ARIZONA BUILDING OFFICIALS
CODE REVIEW AND DEVELOPMENT
COMMITTEE

REPORT OF FINAL ACTIONS
2001-2002

July 15, 2002

FIGURE R602.3(2)
FRAMING DETAILS

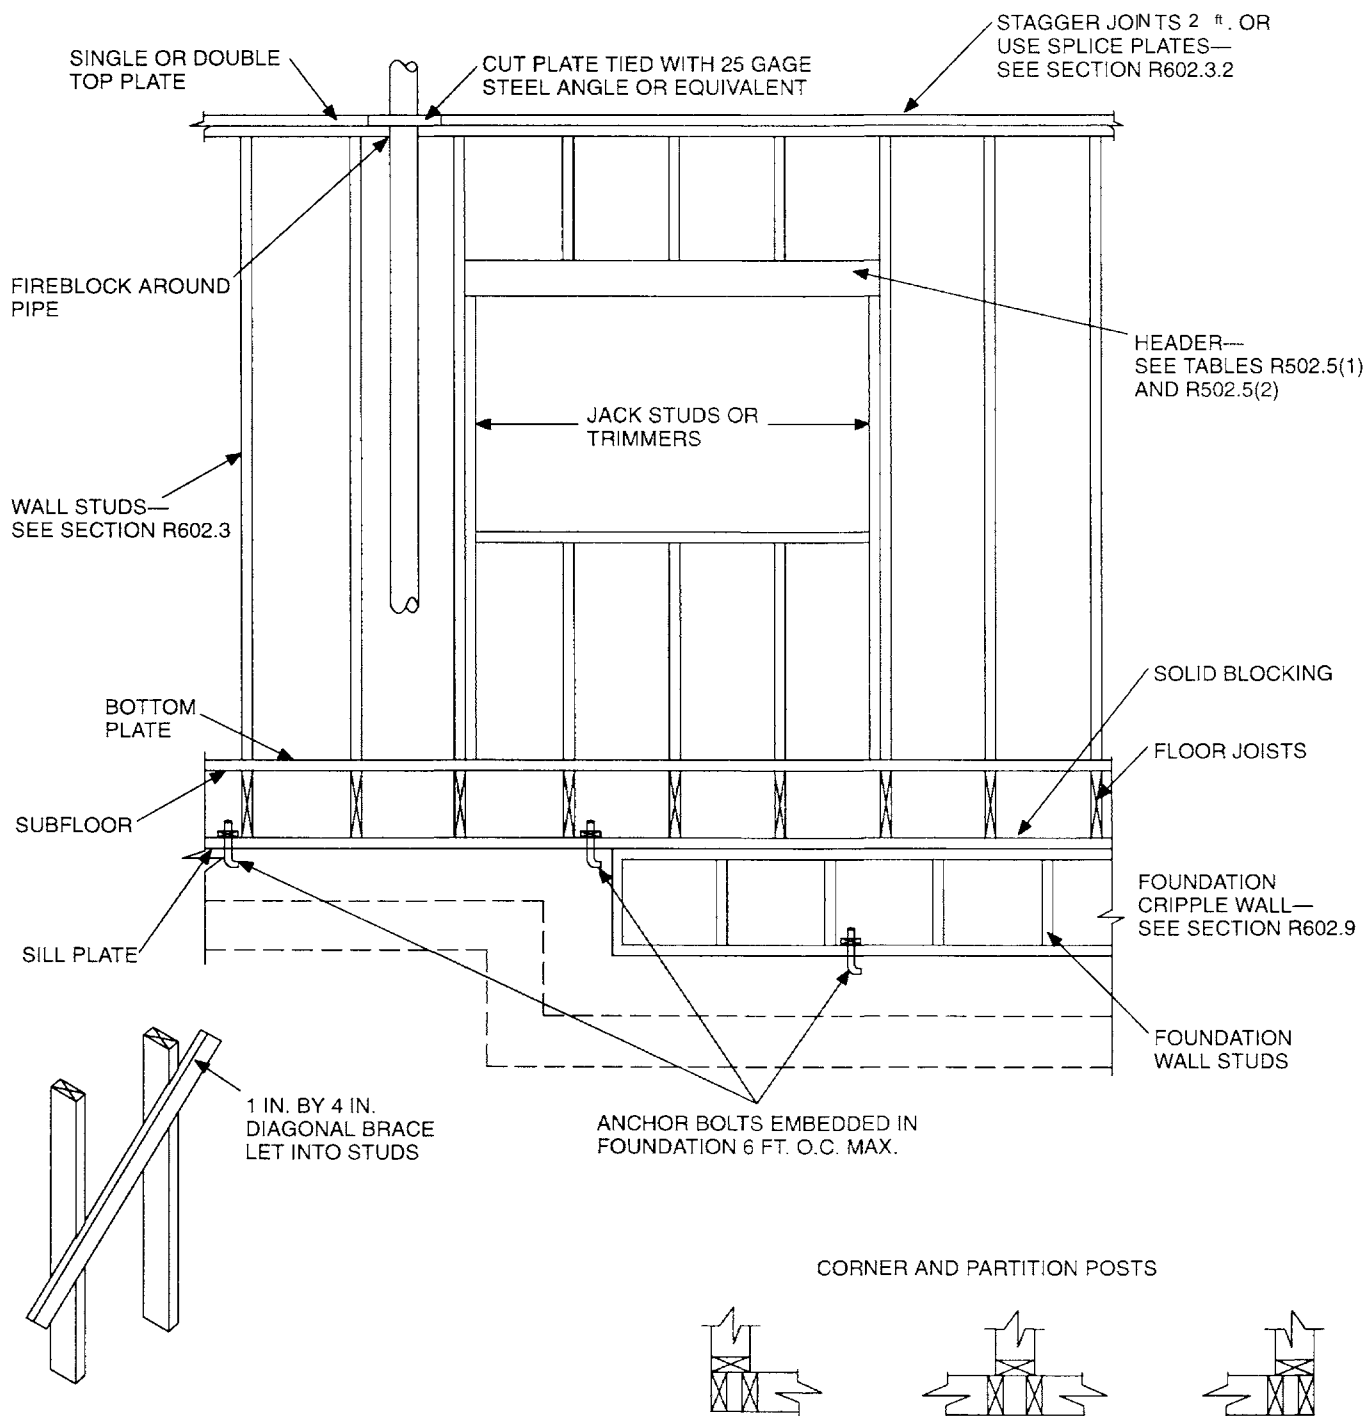
Proposal: Figure R602.3 (2) Framing Details The note in the upper right corner of the page is edited to read “STAGGER JOINTS 24 ~~ft~~ IN. OR USE SPLICE PLATES—SEE SECTION R602.3.2”.

The remainder of the figure is to remain unchanged.

Reason: Section R602.3.2 states, “End joints in top plates shall be offset at least 24 inches (610 mm).” By revising the Figure, the information is consistent with the text of the code.
